MODEL: 2009 ~ 2012 Concours™ 14 & 14 ABS MODIFIED BY BEAUDRY MOTORS, INC. & BMS, INC. FOR LAW ENFORCEMENT USE (ZG1400A9F/L, B9F/L, CAF/L, DAF/L, CBF/L, CCF/L)
TITLE: CONCOURS 14 & 14 ABS MAIN FUSE & WIRING

RECALL

Subject

Inspect MNSTAR Wire Harness:

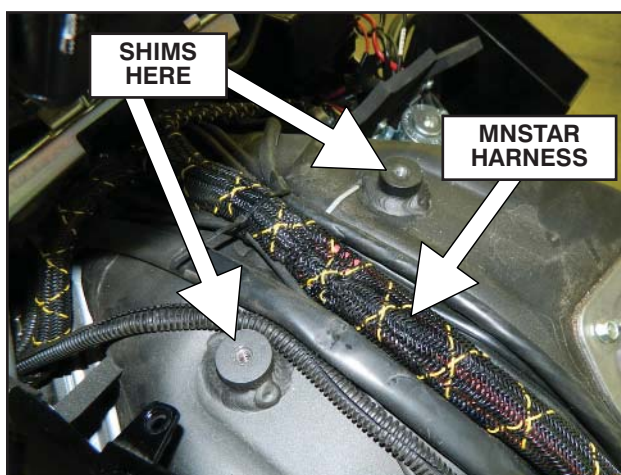
- Remove the fuel tank and discard the two forward mount bolts.
- Inspect the exposed portions of the MNSTAR wire harness (black with yellow stripe) for damage.
- Repair the MNSTAR wire harness as required.
- Install the shims in the Shim Kit (p/n 99969-3105) between the fuel tank and the two forward fuel tank mount points during reassembly. Use the new (longer) bolts included in the kit.

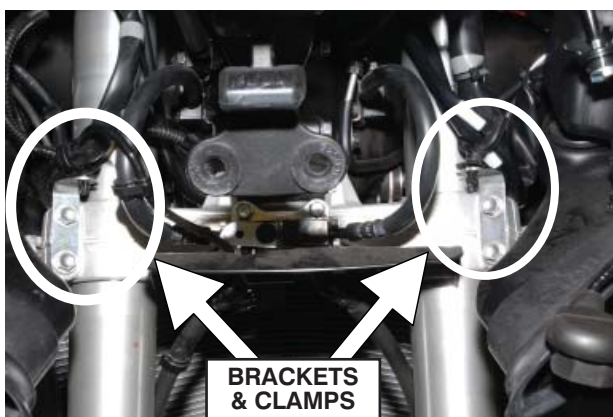
- Remove the cable clamp and bracket from the left and right lower-outside triple clamps.

- Re-install triple clamp bolts and tighten to 30 N·m (3.1 kgf·m, 22 ft·lb).
- Secure cables and wires to prevent damage and binding when handlebar is turned stop-to-stop.

Replace Main Fuse:

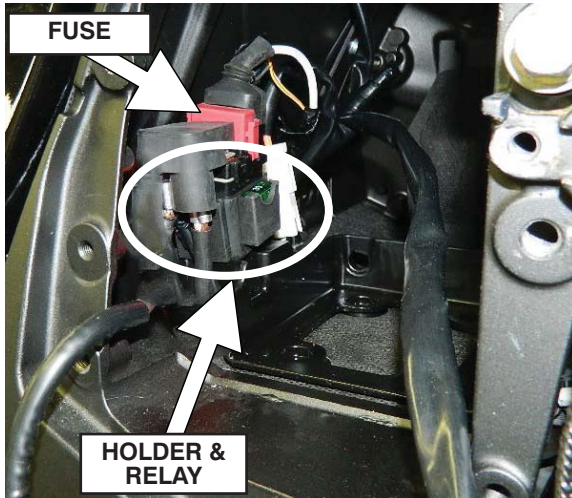
- Remove and replace the 30A main fuse (part number 26006-1080).
- Inspect the fuse holder/starter relay for damage or evidence of overheating. Replace as required.

- o *Replace the fuse regardless of its appearance.*
